Re: FCC ID QLAMID
Applicant: Mala GeoScience AB (publ)
Correspondence Reference Number: 24228
731 Confirmation Number: EA364767

Figure 1. Pulse characteristic of a MID UWB-unit.

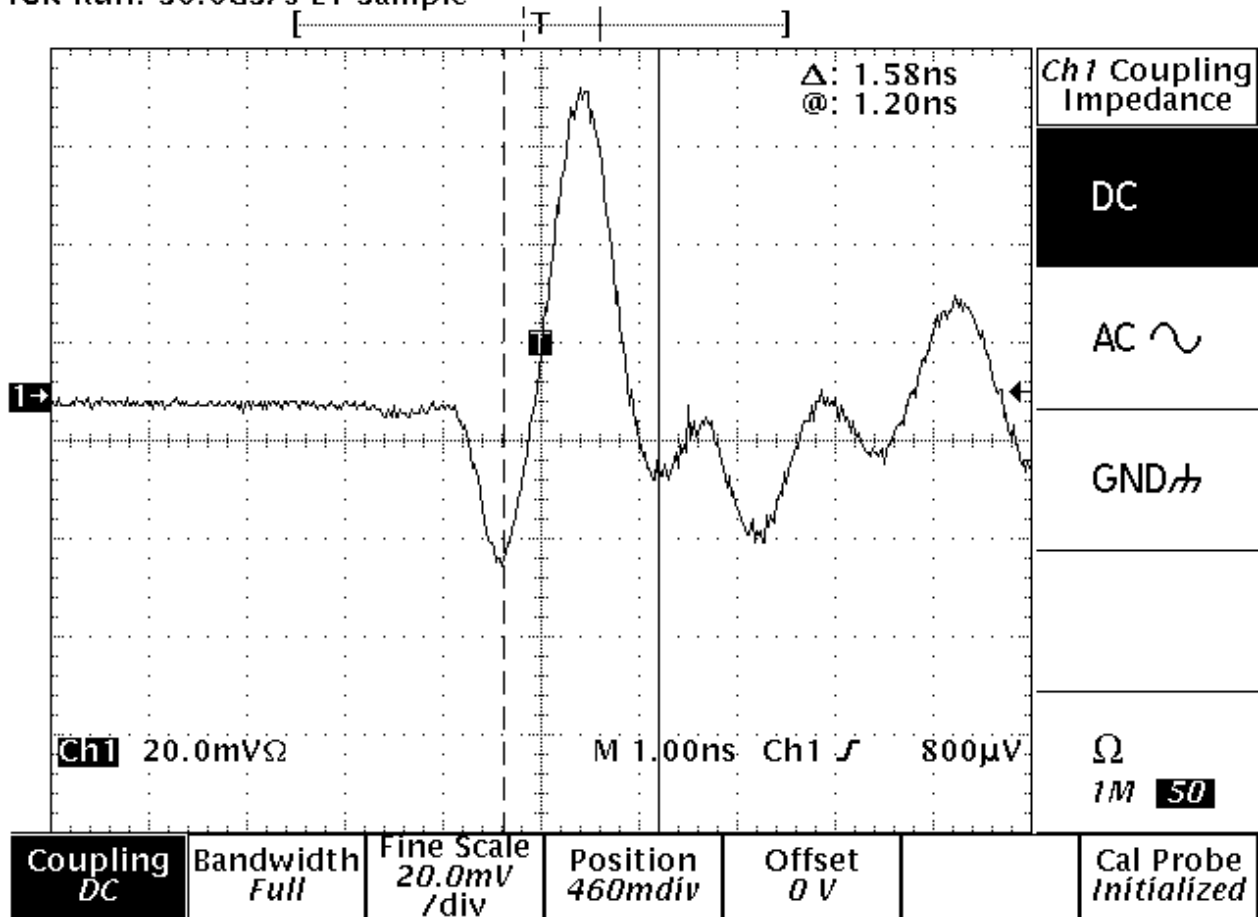
9) What is the pulse width of this device. Is the pulse random (dithered) or periodic? Upload an exhibit with the pulse characteristics of this device. Include a plot.

The MID MHz UWB-unit has a pulse width of about 1.6 ns, in air. A plot of the pulse is shown in figure 1 below. The pulse is periodic with a repetition frequency of 100 kHz.
